DETAILED ACTION

Claim Rejections - 35 USC § 103

2. Claims 1 - 5 are rejected under 35 U.S.C. 103(a) as being unpatentable over Morse et al (US Patent 6,530,237 B2) in view of Tanaka et al (US Patent 6,016,662 A) and as extrinsically evidenced by Petty (US Patent 5,689,880 A)

FIG. 4

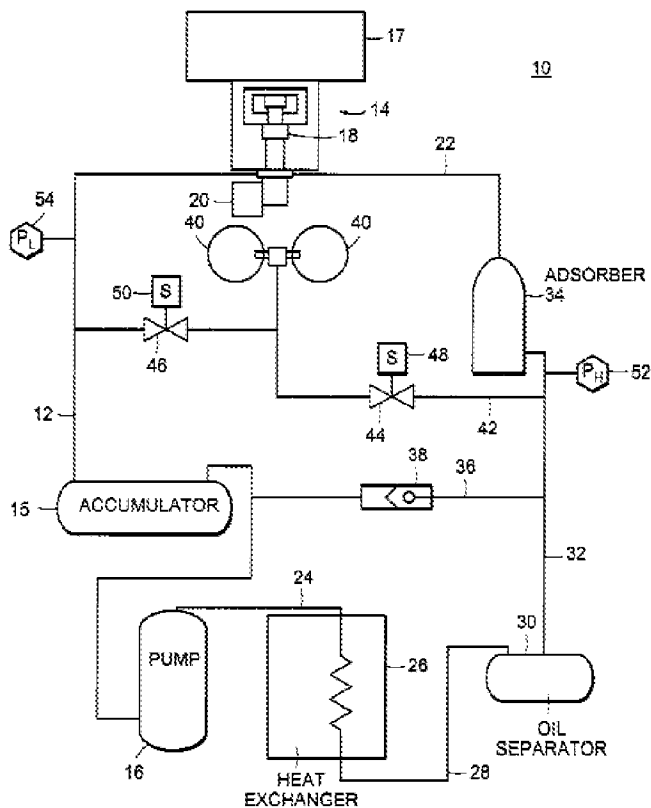
3. In Re claim 1, with reference to Figure 4 above, Morse et al discloses a pumped helium circuit (column 3, lines 25-29) comprising:

- a compressor (16)
- high pressure port which is inherent to the compressor pump outlet
- low pressure port which is inherent to the compressor pump inlet

- supplied equipment (17)
- compressed helium is supplied through line (22) and returns from line (12)
- a pressure relief valve (38) which opens in response to a predetermined pressure differential linking the high and low pressure ports as stated in column 3, lines 55-60: "When the pressure of the helium within the supply line 32 reaches a certain point beyond the pressure necessary to overcome the bias against the valve, the valve opens to allow helium to flow from the helium supply line to the helium return line 12.."

- With regards to "means for preventing oil carry-over from the compressor to the supplied equipment, characterized in that said means comprises means for preventing oil leaving the low pressure port and traveling towards the supplied equipment" within claim 1, this limitation meets the three prong test per MPEP 2181 and thereby invokes 35 USC 112 6th paragraph. The means for preventing oil carry-over from the compressor to the supplied equipment has been disclosed in the specification as a gas reservoir, oil trap or an oil adsorber which prevents oil from leaving the low pressure port and travels towards the supplied equipment. Morse et al discloses an accumulator (15) which provides a "Buffer" as stated in column 3, line 31, and positioned between the supplied equipment and the compressor. In addition, Petty discloses evidence in

Column 1, Lines 13 – 18 that an accumulator typically interposed between an evaporator (supplied equipment) and compressor can function as an oil trap. Also, as applicants suggest in their response to the first office action, the buffer of Morse et al smooths variations in pressure and in order to perform the smoothing function the accumulator needs to be a gas reservoir. The accumulator (15) of Morse et al is therefore is an equivalent element for at least an oil trap or gas reservoir.

Figure 5 of Tanaka et al

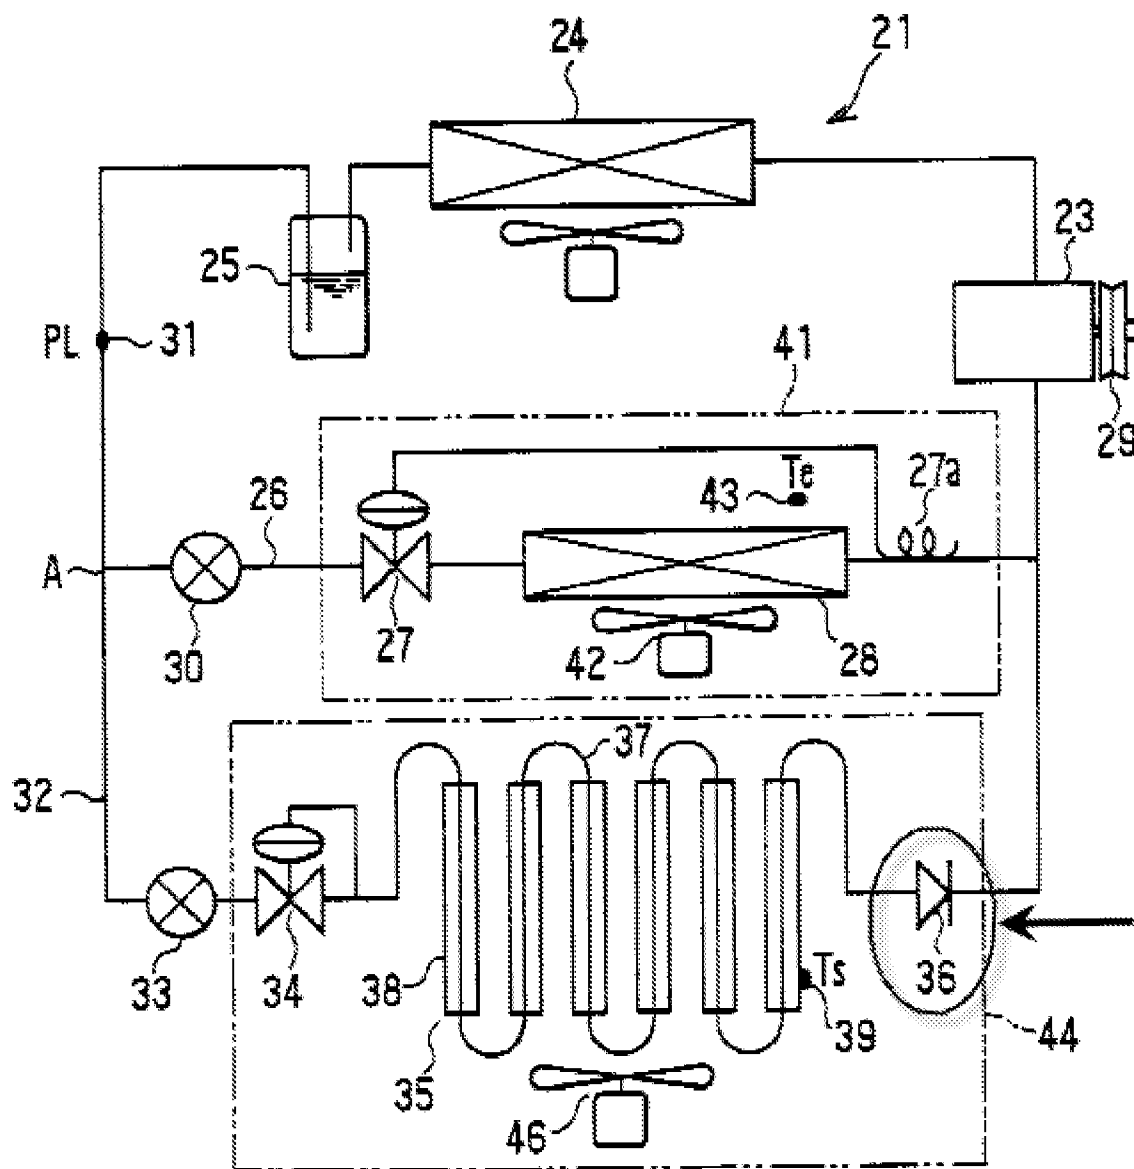
5. Nevertheless, Figure 5 of Tanaka et al discloses a vehicle air conditioning apparatus comprising a Check Valve (36), a non return valve disposed close the supplied equipment (evaporator) in a refrigeration circuit.

6. It would have been obvious to a person having ordinary skill in the art at the time of the invention to modify the pumped helium circuit of Morse et al to incorporate the check valve of Tanaka et al in the helium circuit between a low pressure side of the pressure relief valve and the supplied equipment for the purpose of ensuring one way flow of refrigerant.

Fig-5

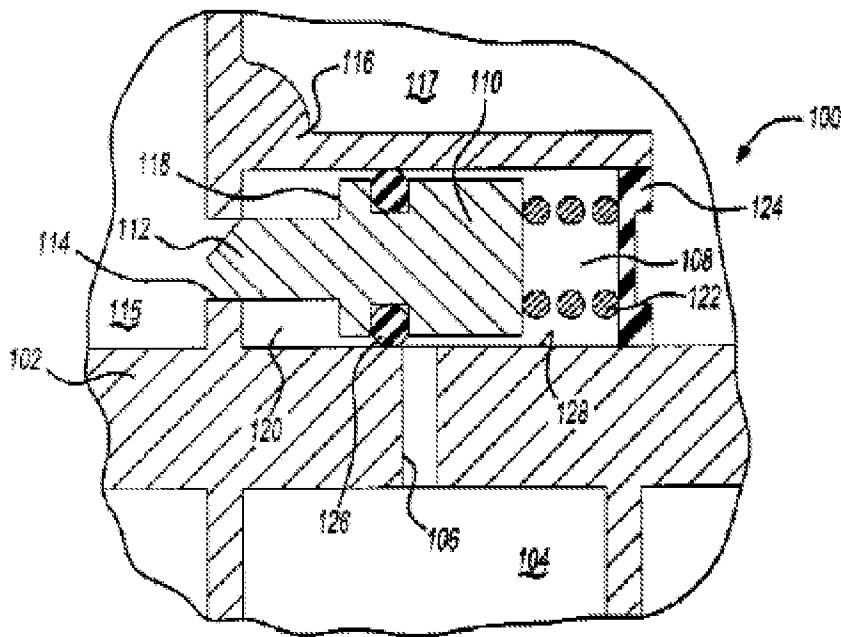
18. Nevertheless, in Figure 5 depicted above, Hugenhroth et al discloses in Column 5, Lines 29-37, a compressor with a valve element (110) that moves to the right when the pressure in chamber (115) is "too high" and relieves the pressure in chamber (115) to chamber (117) independent of low pressure port. In the process, this pressure relief system avoids additional lines on the non return side thus reducing the potential for additional oil migration.

19. It would have been obvious to a person having ordinary skill in the art at the time of the invention to modify the compressor disclosed by Morse et al to incorporate the pressure relief valve element of Hugenhroth for the purpose of protecting the compressor as stated by Hugenhroth in Column 5, Line 38: "...for providing pressure relief, and protecting the compressor..".

BLOWUP OF FIGURE 1 OF Petty

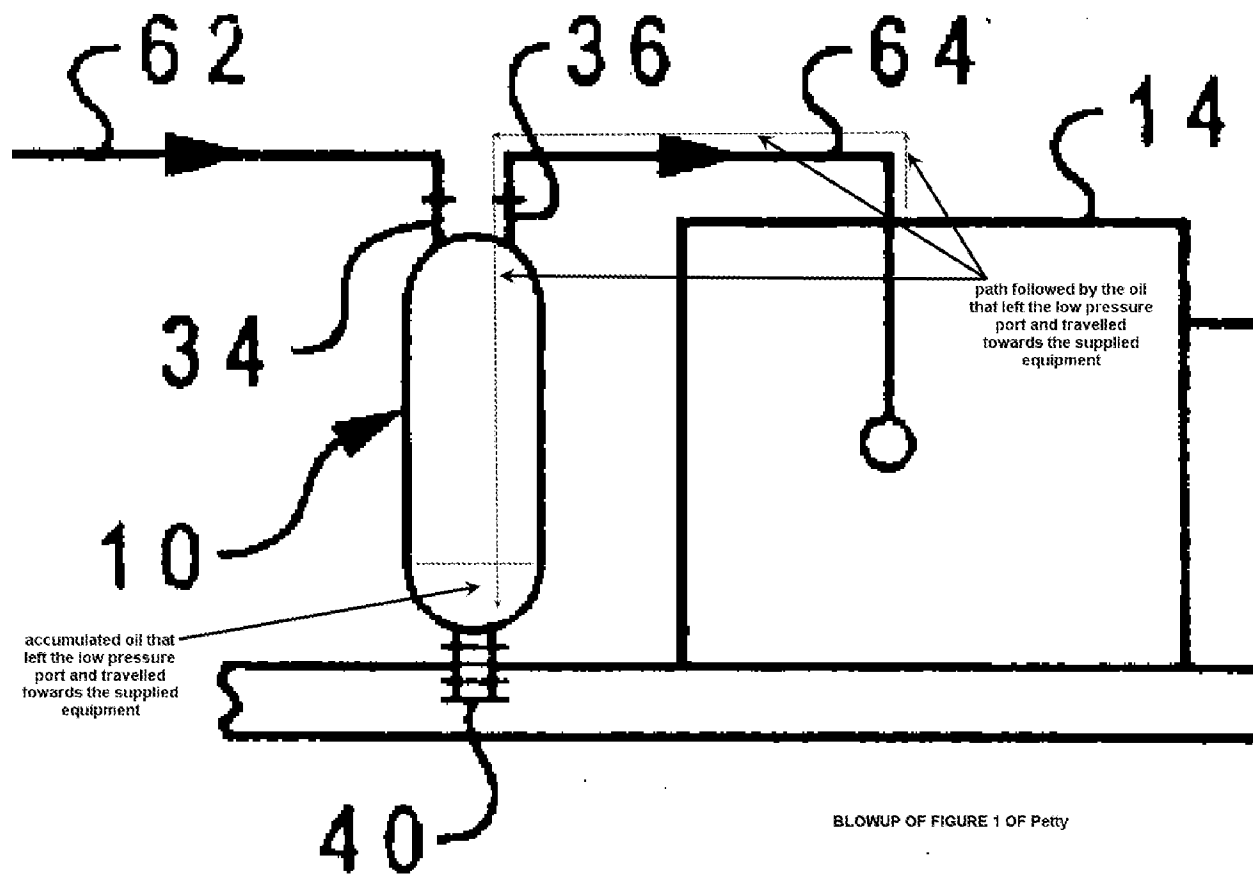
28. Applicants' argument has been carefully considered but it is not persuasive for the following reasons: If the accumulator of Morse et al functions as the accumulator of Petty, it would be INHERENTLY capable of preventing oil from "traveling towards the supplied equipment" because the accumulator of Petty is also INHERENTLY capable of preventing oil from "traveling towards the supplied equipment". Oil migrates along the low pressure line (64) however, the accumulator (10) PREVENTS IT FROM GOING ANY FURTHER beyond it into line (62). This is even more likely with the accumulator of Petty since the oil migrating into the inlet of the accumulator would trickle to the bottom of the elongated chamber of the accumulator and not reach line (62).

29. The blowup depicted above of Figure 1 of Petty illustrates the path of migration of oil along the low pressure return lines by dotted arrows and demonstrates by the annotations how the migrating oil would trickle into the accumulator. Note that the liquid phase of the refrigerant entering from line (62) into the accumulator is also “trapped” at the bottom as stated in Column 4, Lines 39-42 of Petty. Also as mentioned in the earlier office action, Petty clearly discloses in Column 1, Line 17: “The accumulator functions to trap oil ..” which is highly suggestive to one of ordinary skill in the art that the accumulator of Morse et al also “functions to trap oil”.
